Southern Nuclear Operating Company
Vogtle Electric Generating Plant Units 3 and 4
Request for License Amendment and Exemption:
ADS and IRWST Injection Block (LAR-16-018)

- Enclosures:
- 1) Vogtle Electric Generating Plant (VEGP) Units 3 and 4 – Request for License Amendment Regarding ADS and IRWST Injection Block (Publicly Available Information) (LAR-16-018)

- 3) Vogtle Electric Generating Plant (VEGP) Units 3 and 4 – Proposed Changes to Licensing Basis Documents (Publicly Available Information) (LAR-16-018)

UFSAR Section 7.2, Figure 7.2-1, Sheet 15 of 21 (changes reflected in clouded areas)

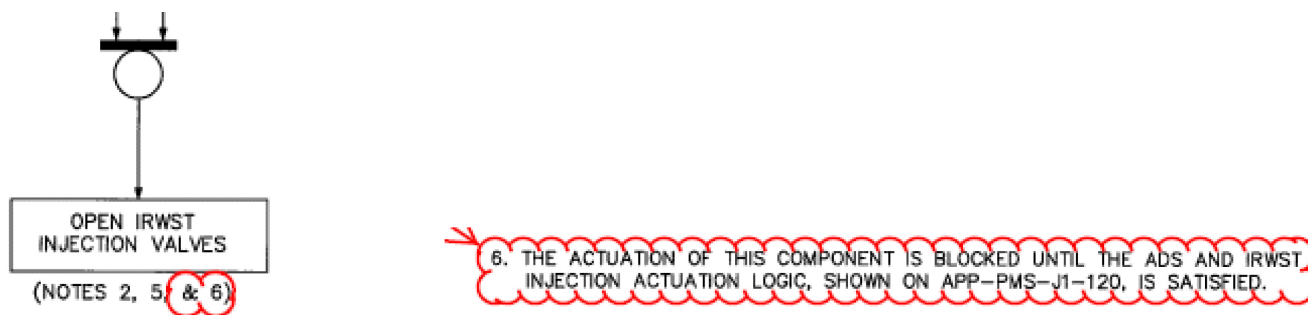
The low CMT level signals, the low battery charger input voltage signals, the manual unblock signal, and the remote shutdown workstation (RSW) transfer signal are logically OR'ed (OR logic gate) together in the circuitry of the ADS and IRWST injection blocking device in each division. The result of this OR'ing is used to remove the block signal to the CIMs. This design feature is reflected in the proposed revision to UFSAR Figure 7.2-1 (Sheets 15 and 19).

(Existing Note 8 is replaced with the above Note 8)

UFSAR Section 7.2, Figure 7.2-1, Sheet 16 of 21 (changes reflected in clouded areas)

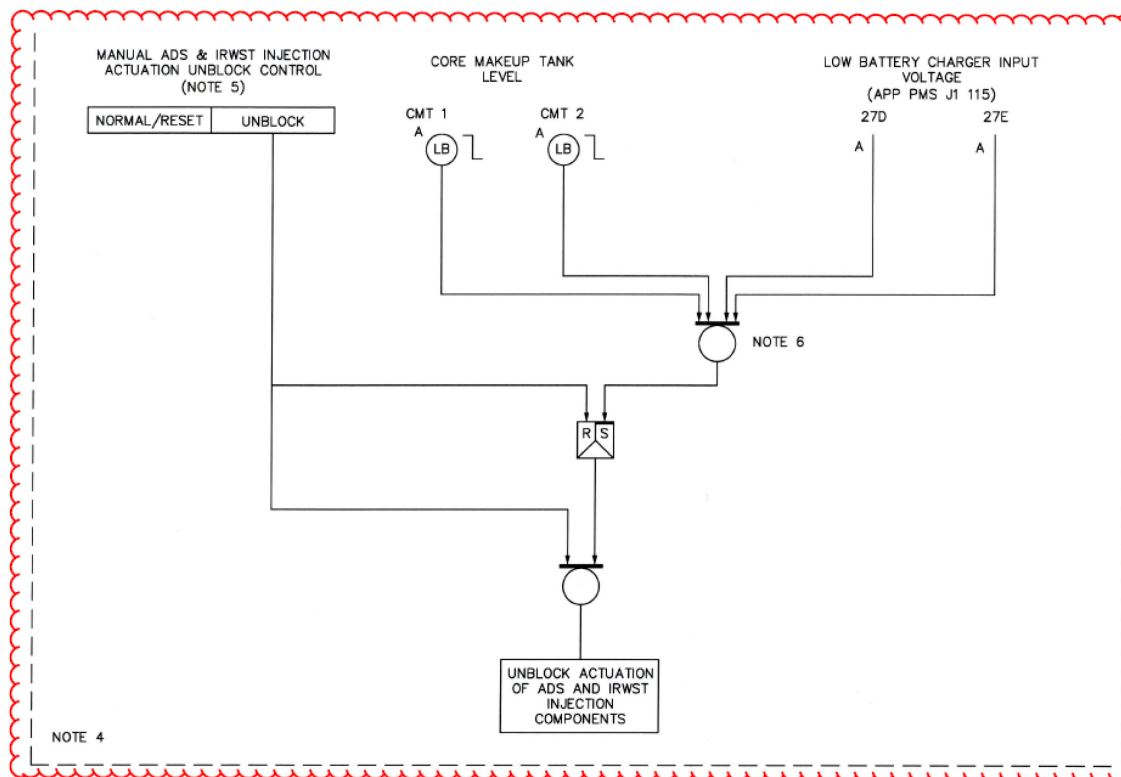
* * *	* * *	* * *	* * *
21. Open In-Containment Refueling Water Storage Tank (IRWST) Injection Line Valves <u>Valves⁽⁹⁾</u> (Figure 7.2-1, Sheets 12 and 16 <u>12, 16, and 19</u>)			
* * *	* * *
